**Kamman Hydrology & Engineering, Inc.**

Subject: Review of Final Environmental Impact Report  
SCH No. 2004031114  
The Church of the Woods Project, Rim Forest, California

FIGURE 3: Proposed Church of the Woods (COTW) Site Plan (source: County of San Bernardino, 2016).

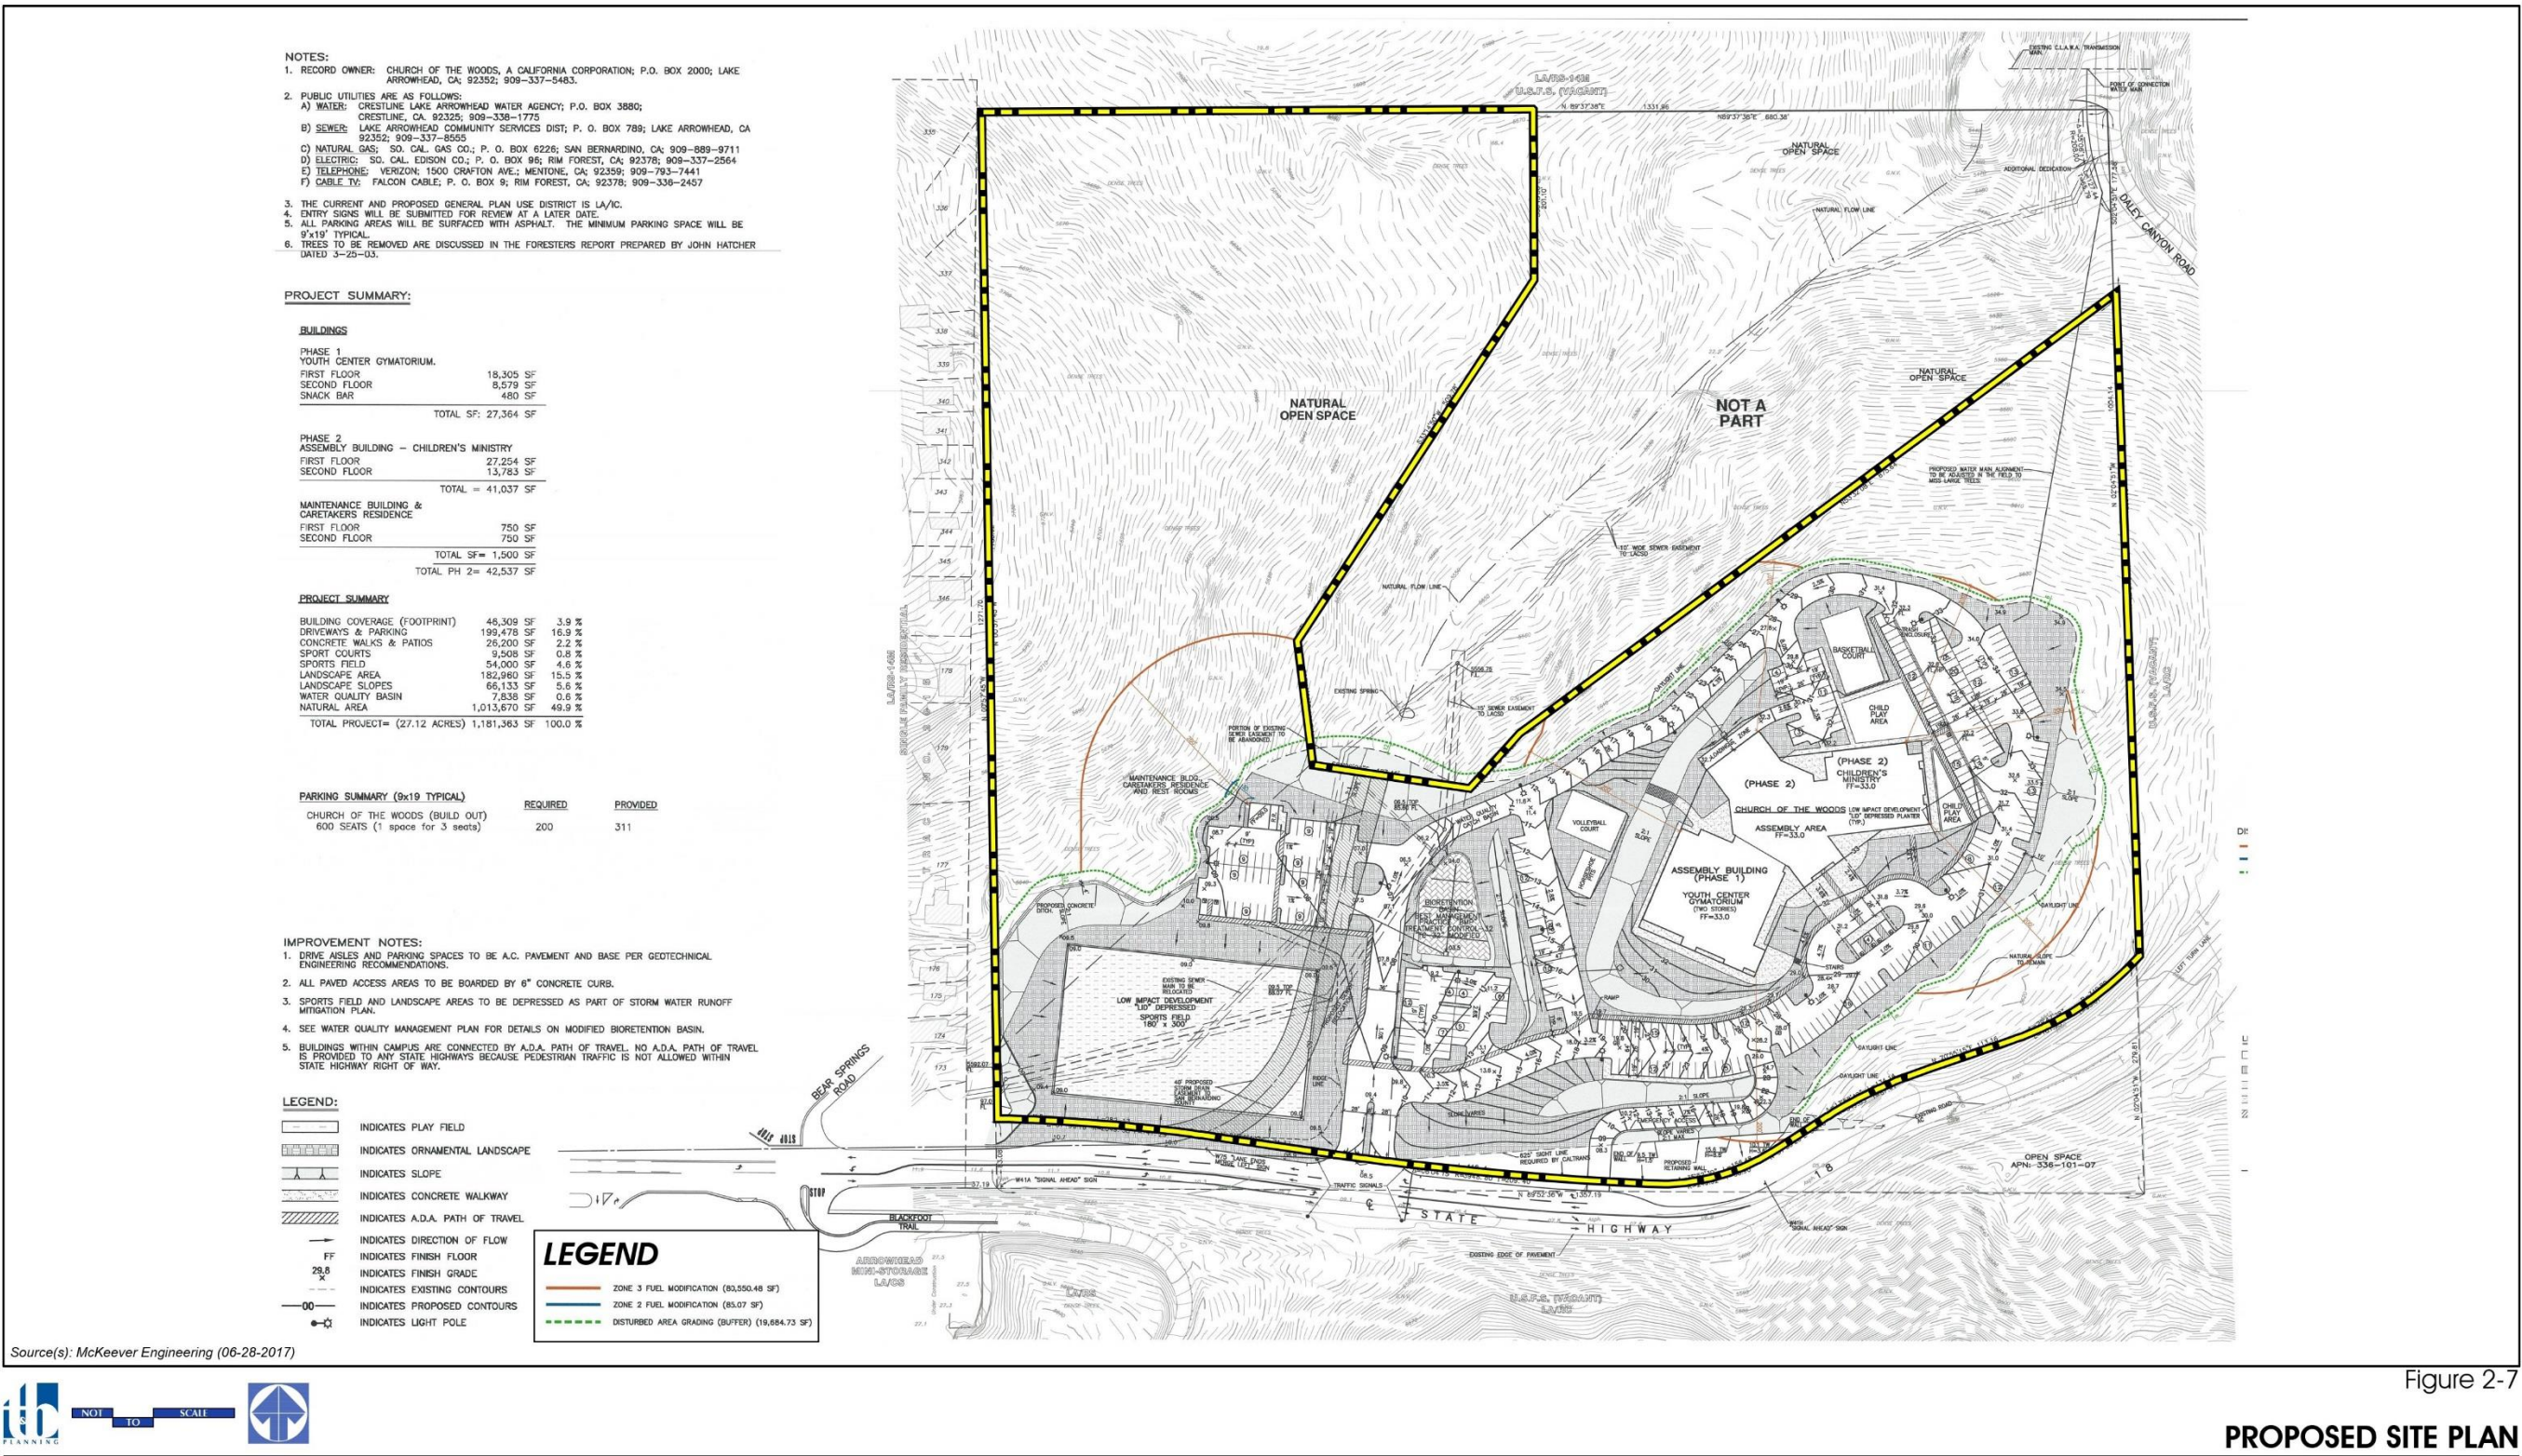
The COTW's delineation of jurisdictional waters and wetlands on the project property provided in Appendix C<sup>2</sup> of DEIR is consistent with the findings presented in the RSDP DEIR. Maps of jurisdictional wetlands/waters for the COTW and RSDP projects are provided in Figures 1 and 2, respectively. Both maps indicate that jurisdictional waters lie within the construction footprint of the proposed COTW project (Figure 3).

FIGURE 4: Drainage area to spring (blue shaded area): pre-project (left graphic) and proposed project (right graphic) conditions. Note: impervious surface areas shaded light brown on right graphic.

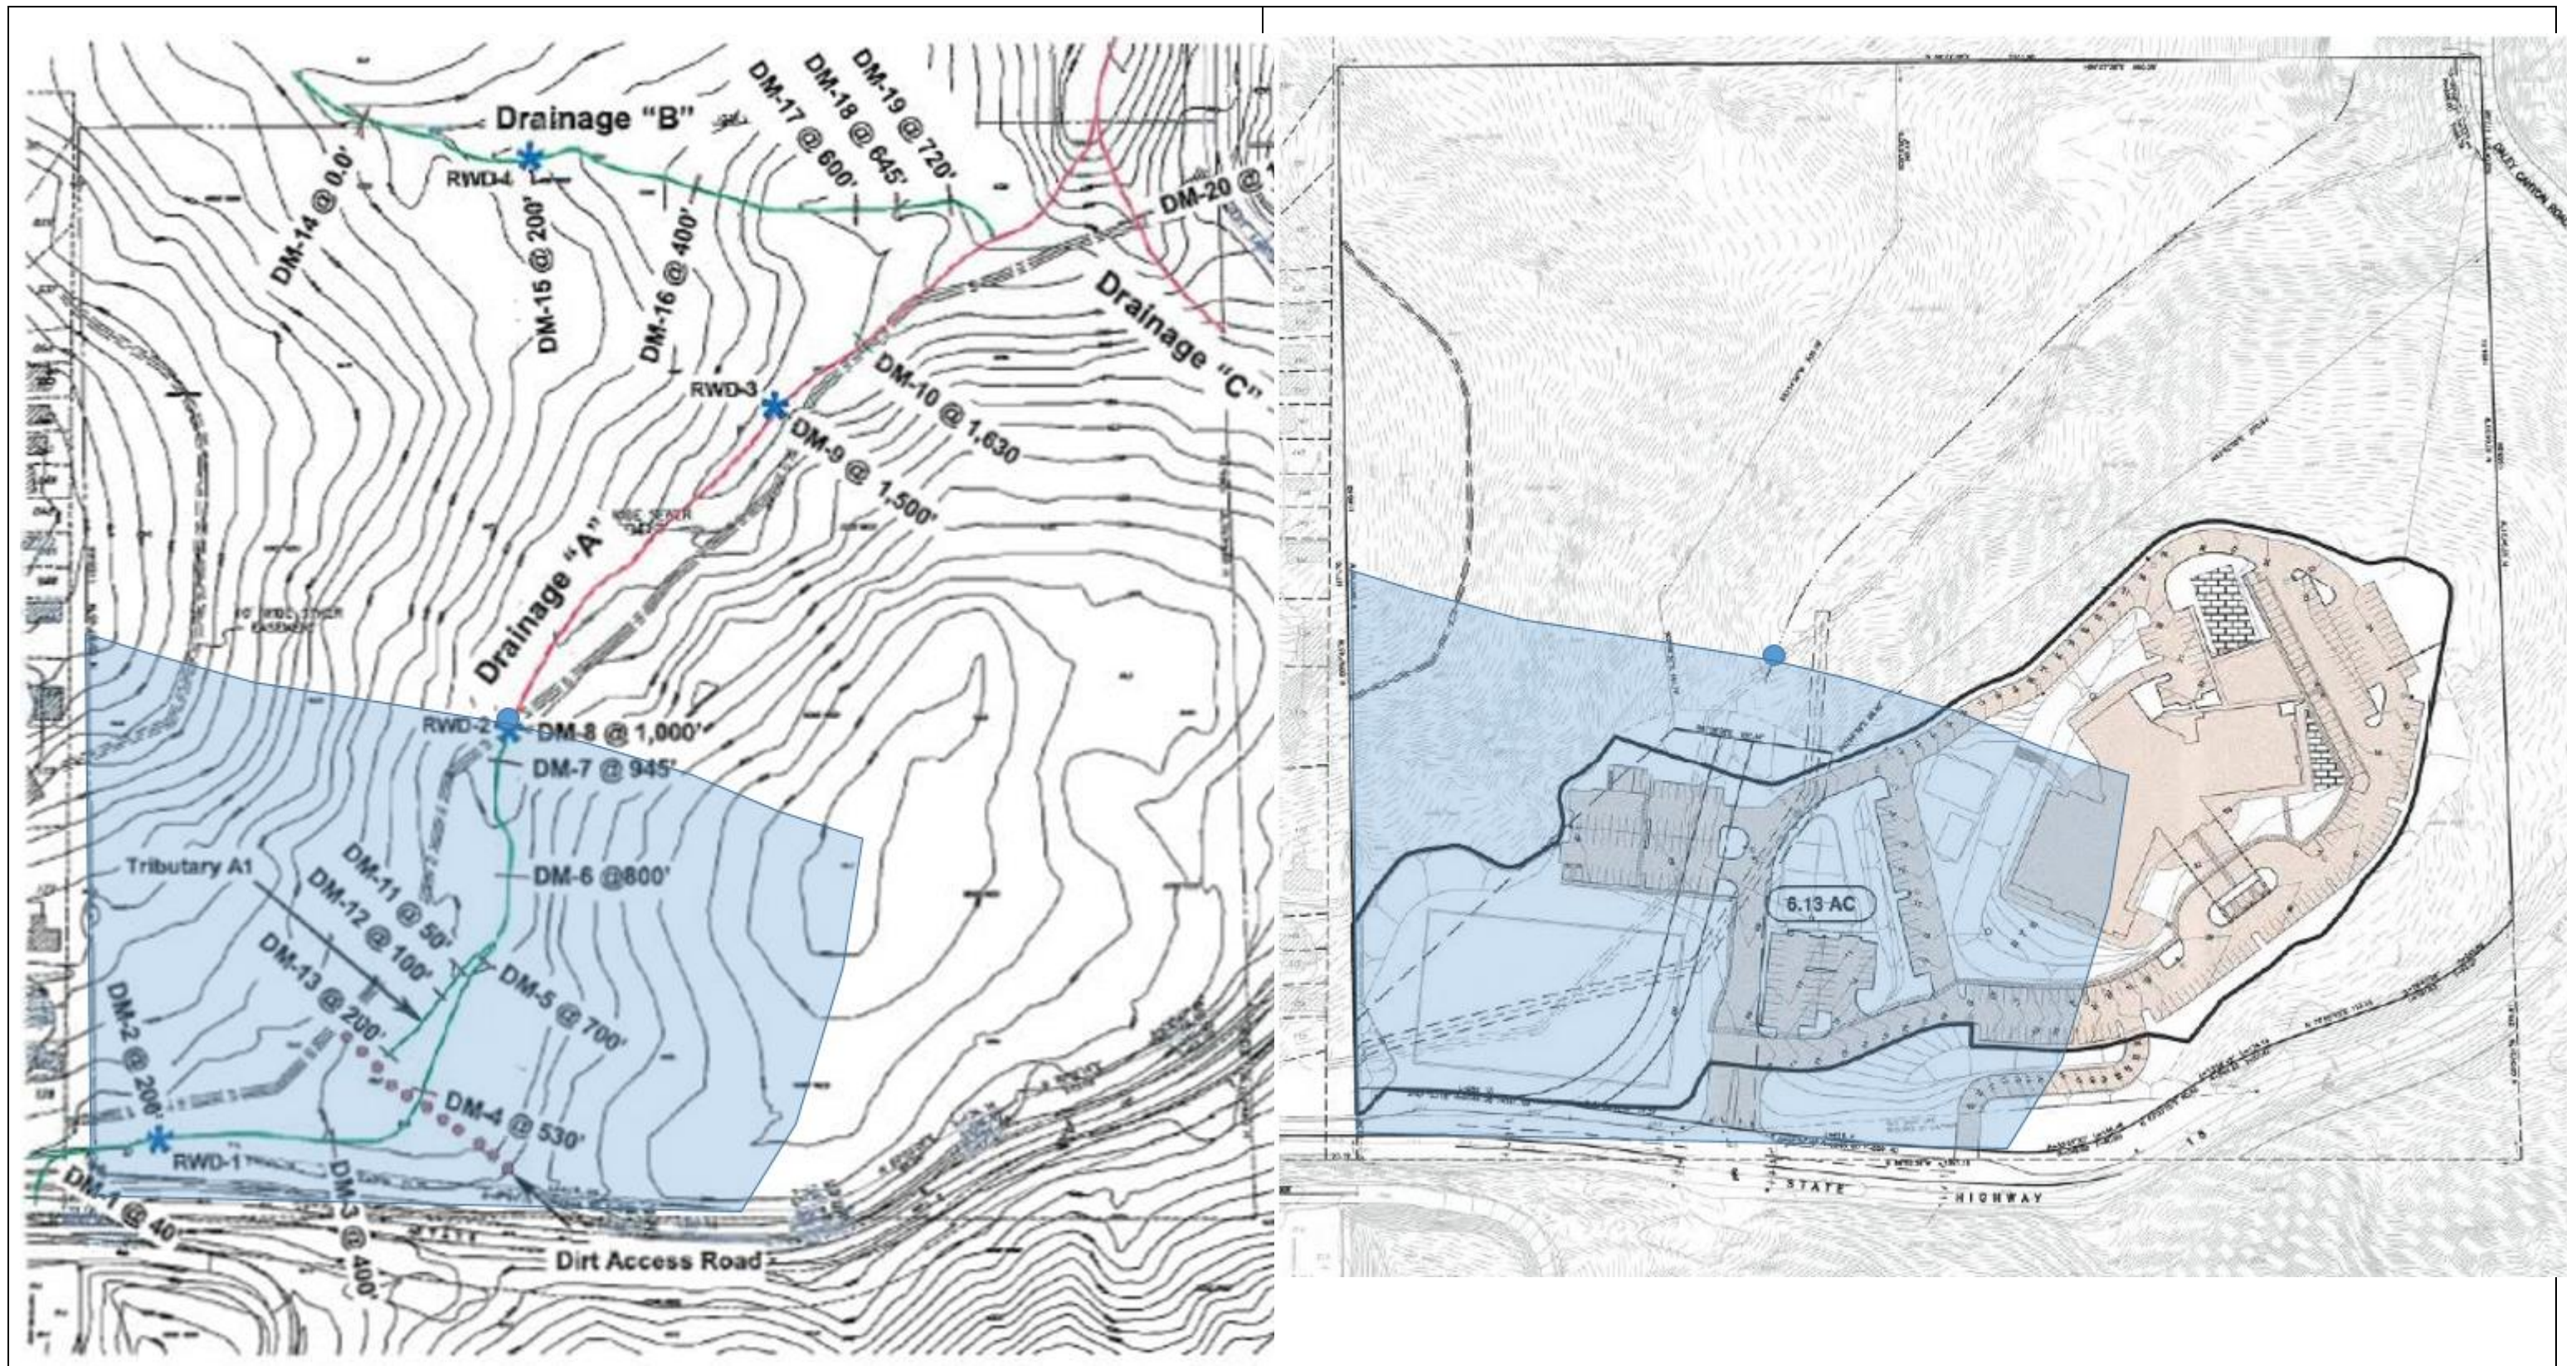
Since a spring is a place where groundwater flows out of the ground, the groundwater emanating from the spring typically comes from the area lying upgradient of the spring. Using the existing (pre-project) contours provided on the COTW jurisdictional wetland/waters map, I've shaded the area lying upgradient of the spring (left graphic in Figure 4). This area represents where infiltration of rainwater will recharge the underlying groundwater upgradient of the spring. Superimposing this recharge area on the proposed COTW project footprint (right graphic in Figure 4), illustrates how much of the recharge area will be influenced by project facilities. If drainage from the impervious surface areas is captured and directed into the RSDP storm drain, this water will be discharged downstream of the spring and is no longer available for groundwater recharge to the spring. Albeit this water will generate creek flow, but it will be ephemeral in nature as it will no longer be stored underground and metered out more slowly – a process that sustains perennial spring flow. The FEIR (response 10-50 on page FEIR-165) states, “The landscaped areas and athletic field would act as infiltration beds to mitigate the increased runoff due to the impervious areas.” However, in my experience, athletic fields are typically constructed with subdrain systems that accelerate drainage off the

field and into storm drains to alleviate saturated conditions and ponding. Given the large percentage of recharge zone that will be covered by project facilities, it seems clear that the COTW needs to analyze how the project will modify and potentially impact both surface and groundwater hydrology and, in turn, spring flows that sustain downstream jurisdictional wetlands and waters. As it stands, the FEIR fails to analyze these potential impacts to hydrologic and biological resources.
